Subject: Transmittal of Class 1 Permit Modification to Clarify Structure Installation and Equipment Use in the Los Alamos National Laboratory (LANL) Hazardous Waste Facility Permit, EPA ID No. NM0890010515

**Class 1 Permit Modification to Clarify Structure Installation and
Equipment Use**

EPC-DO-16-259

Figure 36: Technical Area (TA)-54, Area G, Pad 11

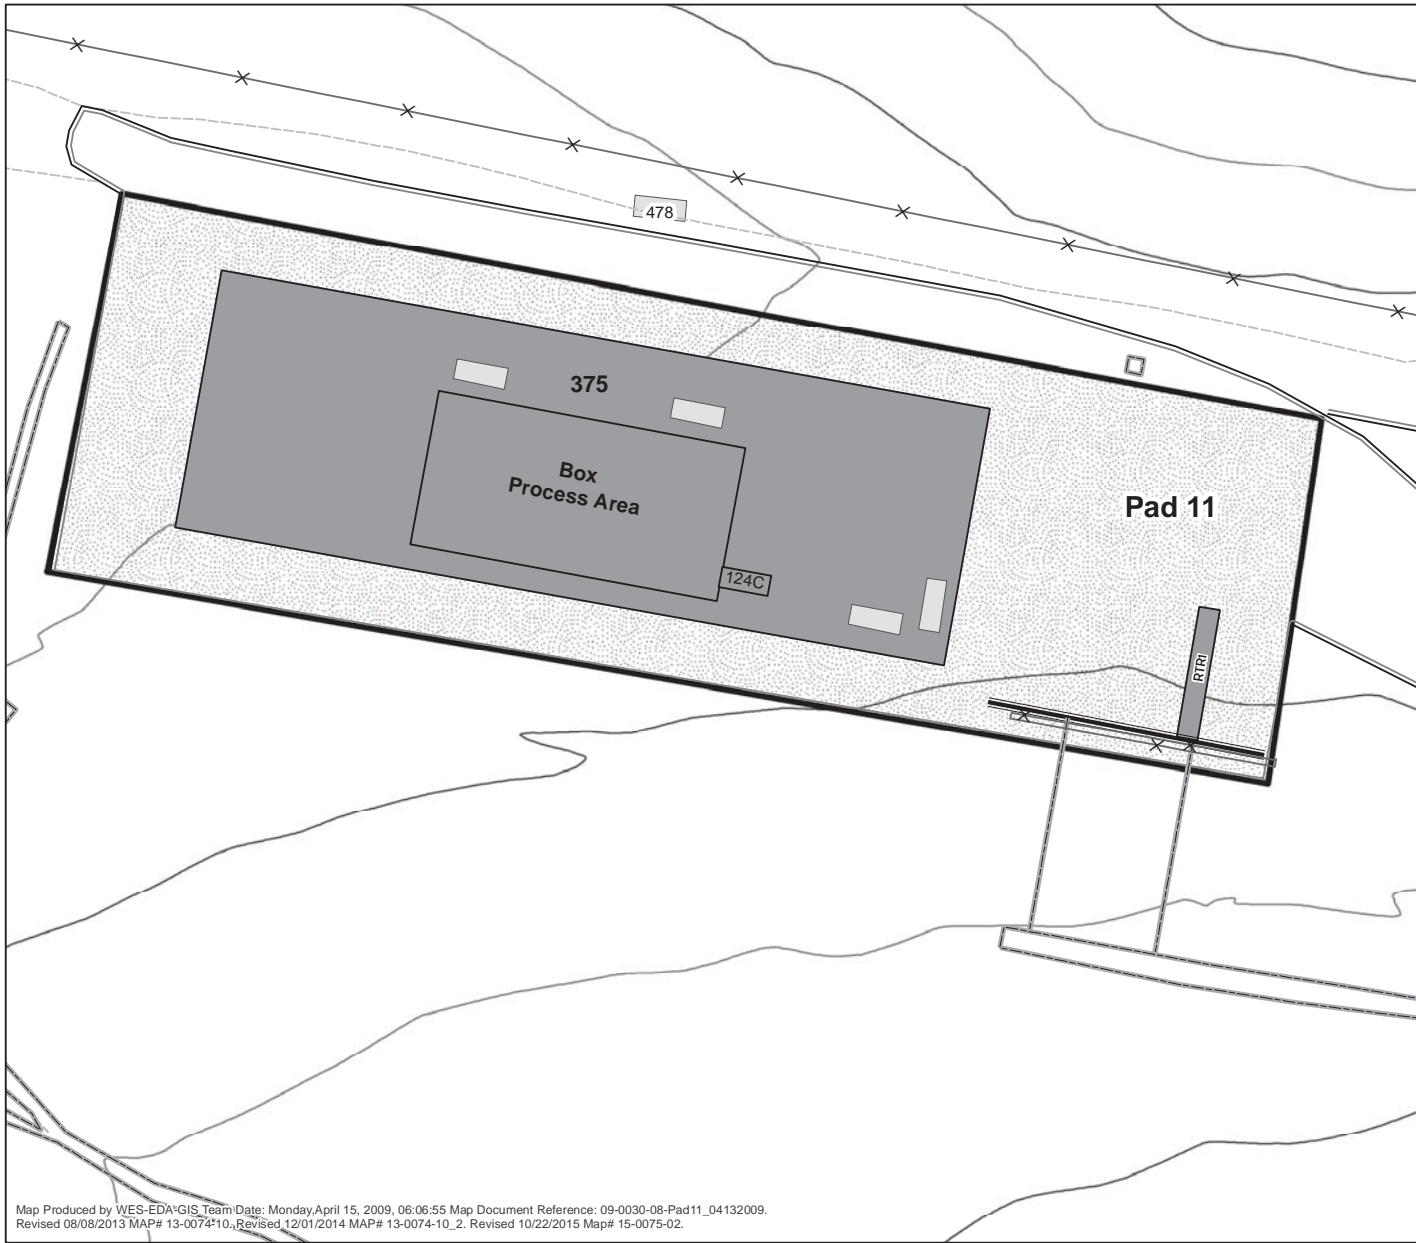
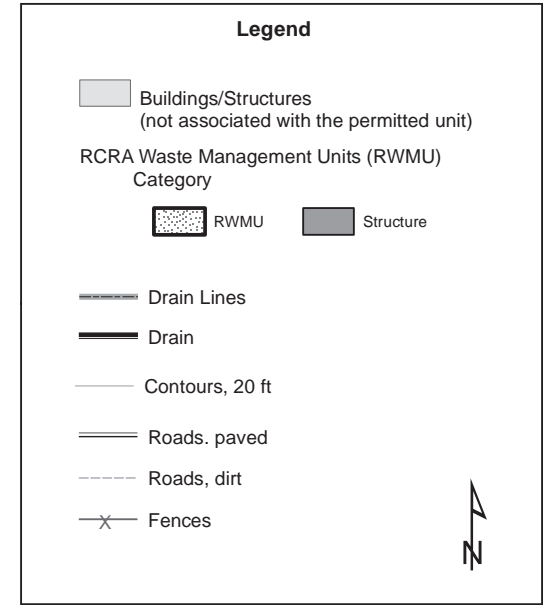
- To replace the “as installed” location of two structures (124B and 124C) inside Dome 375 as well as the associated language previously added to the Permit. A single structure was deemed necessary for temperature controlled storage, therefore only structure 124C was installed.
- To add additional drum handling equipment to Technical Area (TA)-50-69.
- The correction of a typographical error within Attachment A.

Figure 36, *TA-54, Area G, Pad 11* and Figure G.12, *Technical Area 54, Area G, Pad 11 Outdoor Closure Plan*, were revised to reflect the final location of the structure in Dome 375.
